Re: Petition for Modification or Amendment to the Black Oak Wind and Getty Wind large wind energy conversion system site permits and appropriate conditions
Docket Nos. IP-6853/WS-10-1240 (Black Oak), and
IP-6866/WS-11-831 (Getty Wind)

COMMENTS AND RECOMMENDATIONS OF THE MINNESOTA DEPARTMENT OF COMMERCE ENERGY ENVIRONMENTAL REVIEW AND ANALYSIS

DOCKET NO. IP-6853/WS-10-1240, AND IP-6866/WS-11-831

Attachment 10-1240-1 Black Oak Site Map

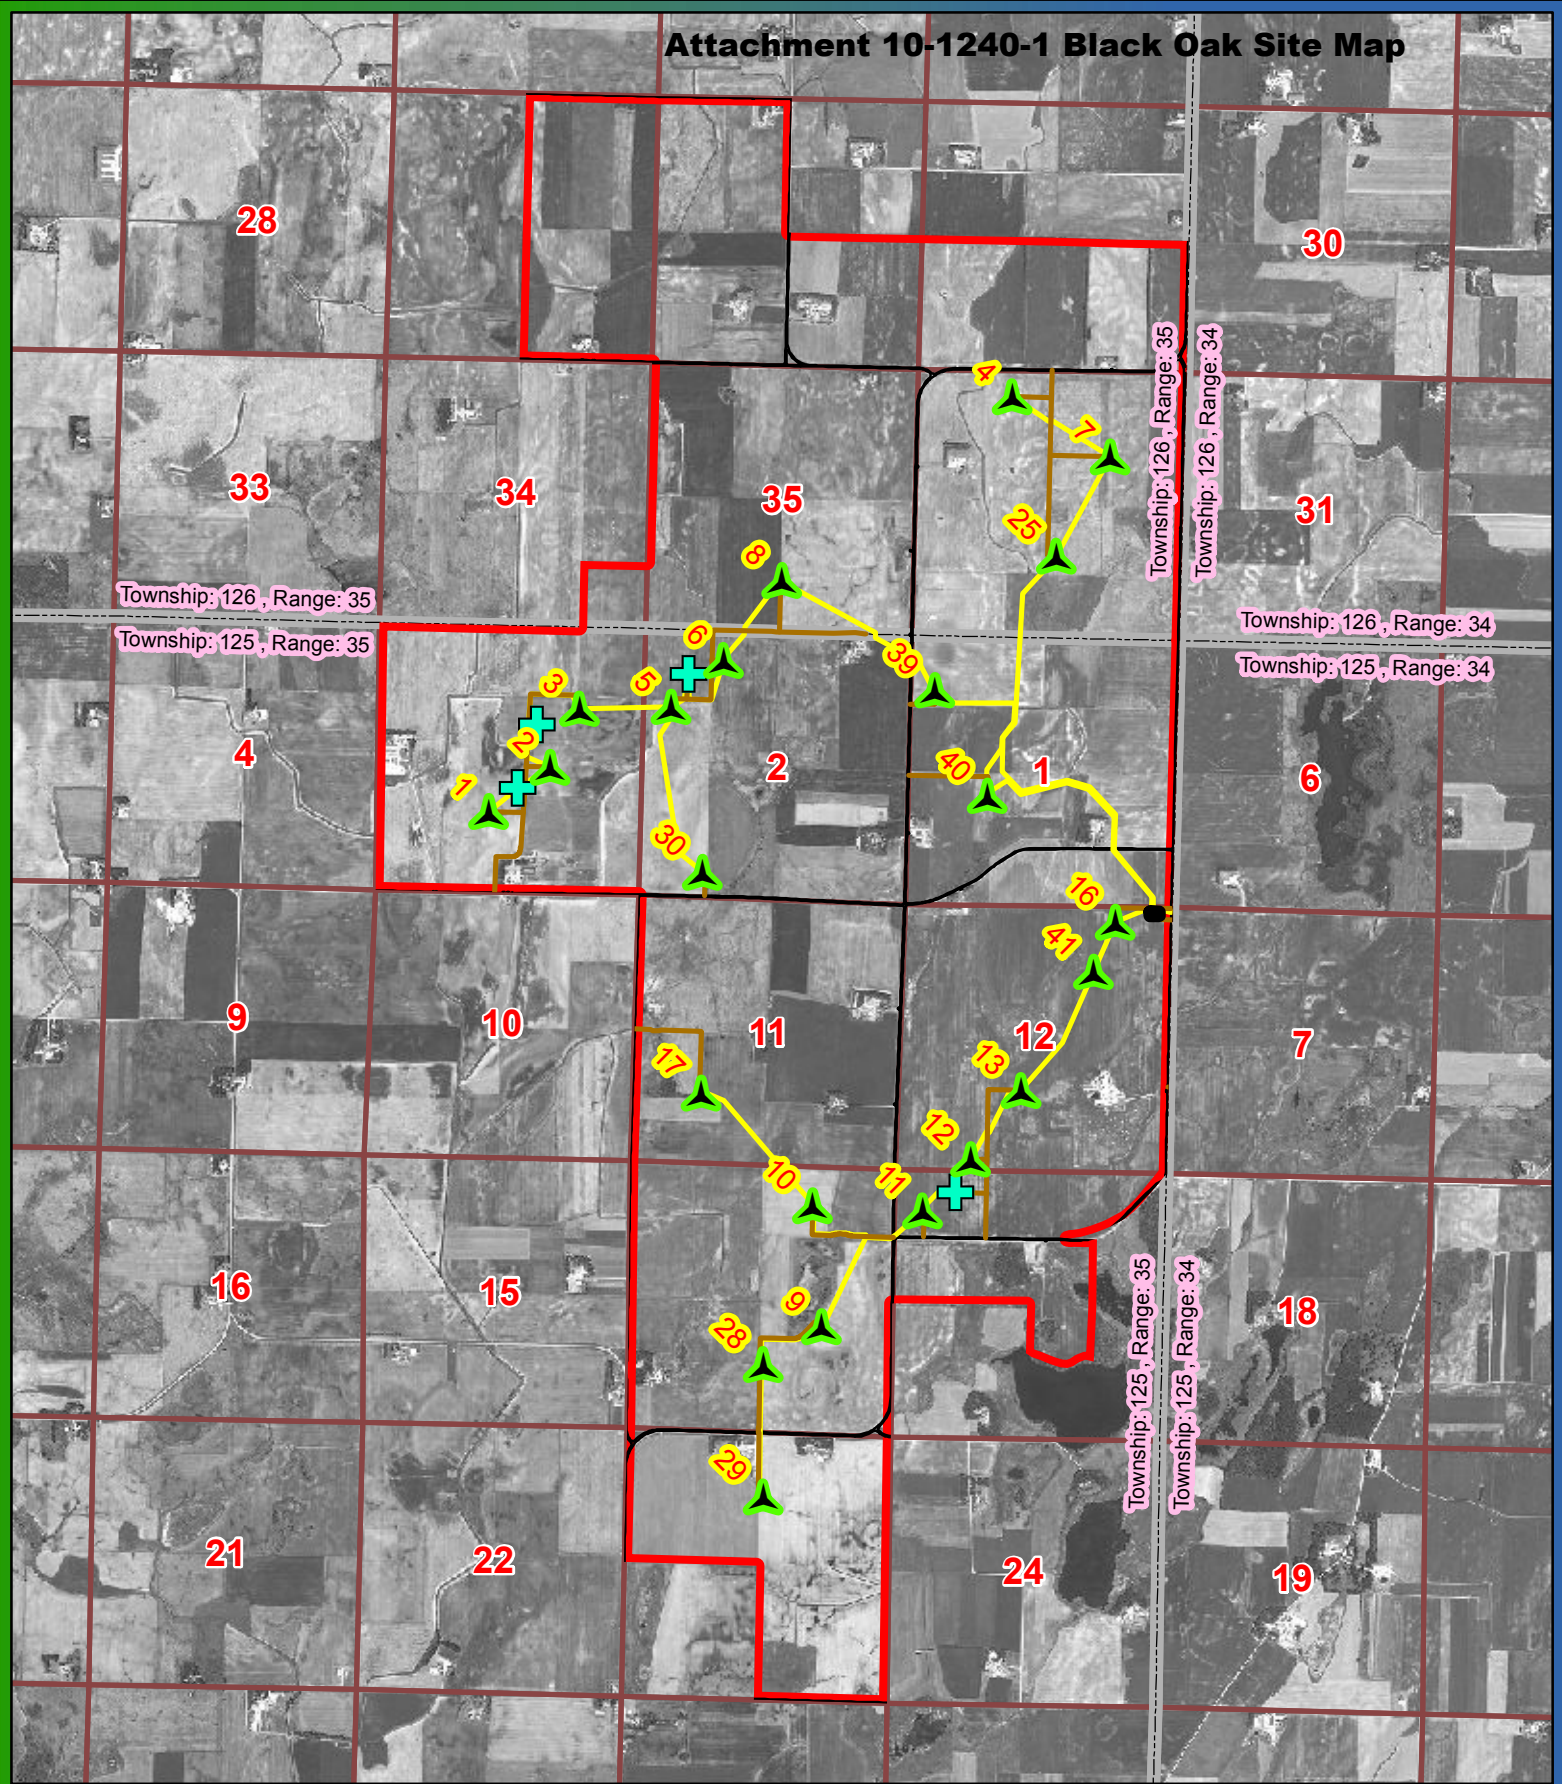
EERA Staff Comments: As discussed in their amendment petition, Black Oak and Getty have now settled on a turbine model and appear to have a well-developed layout. On September 26, Black Oak and Getty filed revised site plans that, among other changes, include turbine layouts separated by project. EERA staff recommends that Attachment 10-1240-1 (Black Oak Site Map) and Attachment 11-831-1 (Getty Site Map), excerpted from the recent Black Oak and Getty filings and included in this filing for convenience, be included as Attachment 1 to each permit, replacing Attachments 1a-c.

EERA staff also recommends that Section 2.2 of the site permits be modified as follows to incorporate the updated maps:

Three preliminary wind turbine and associated facility layouts are shown on maps at Attachments 1a, 1b, and 1c. Each The preliminary layout represents the approximate location of wind turbines and associated facilities within the Project boundary and identifies a layout that minimizes the overall potential human and environmental impacts of the Project, which were evaluated in the permitting process. The final layout depicting the location of each wind turbine and associated facility shall be located within the Project boundary. The Project boundary serves to provide the Permittee with the flexibility to make minor adjustments to the preliminary layout to accommodate landowner requests, unforeseen conditions encountered during the detailed engineering and design process, and federal and state agency requirements. Any modification of the location of a wind turbine and associated facility depicted in the preliminary layout shall be done in such a manner as to have comparable overall human and environmental impacts and shall be specifically identified in the site plan pursuant to Section 5.1. The Permittee shall submit the final site layout in the site plan pursuant to Section 5.1.
